**ALTERATION TO A HISTORIC PROPERTY STAFF REPORT**

Site / District(s)      34 Day Street / Single Building LHD/NR  
Case:                      HPC 2012.095

Date of Application:    8/27/2012  
Legal Notice:           Enclose rear left side section of front porch with door.

Left: Screens proposed to be removed and location of second door to enclose section of porch with windows

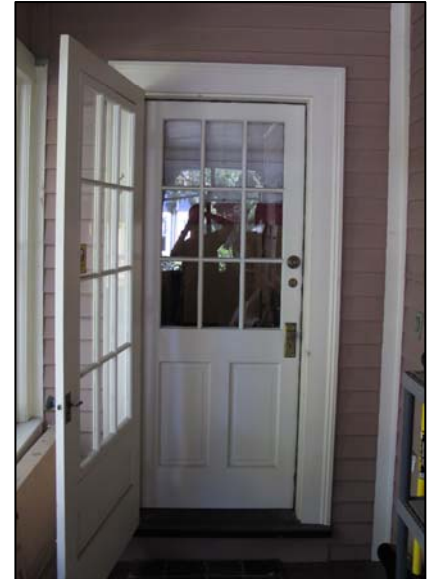
The removal of the screens and screen door from the front portion of the porch will be highly visible; however, the screens and door are not original and their removal will enhance the visible details of the entire porch.

The installation of a new wood and glass panel door and clapboard wall, consistent with the door and wall located at the rear of the porch (see photo above), will also be highly visible. However, this type of door is already a component of the porch and is compatible with the Second Empire style of the dwelling. Evidence illustrates that the rear porch was at some point separated from the front porch at the same location as the proposed new door and wall. The addition of a door to divide the front and back portions of the porch will not negatively affect the historic integrity of the house. This door/wall will be constructed in such a manner that if the current or future owners wish to convert the porch back to the present appearance, the historic fabric of the porch will not be negatively affected.

The installation of a door and wall between the front and rear porch areas is based on evidence that these areas were previously divided at this exact location. Furthermore, the addition of a door in this location will formally divide how the space is already being used by the residents.

- + Staff determines that the alteration for which an application for a Historic Certificate has been filed is appropriate for and compatible with the preservation and protection of the 34 Day Street Local Historic District; therefore **Staff recommends the Historic Preservation Commission to grant 34 Day Street a Certificate of Appropriateness.**
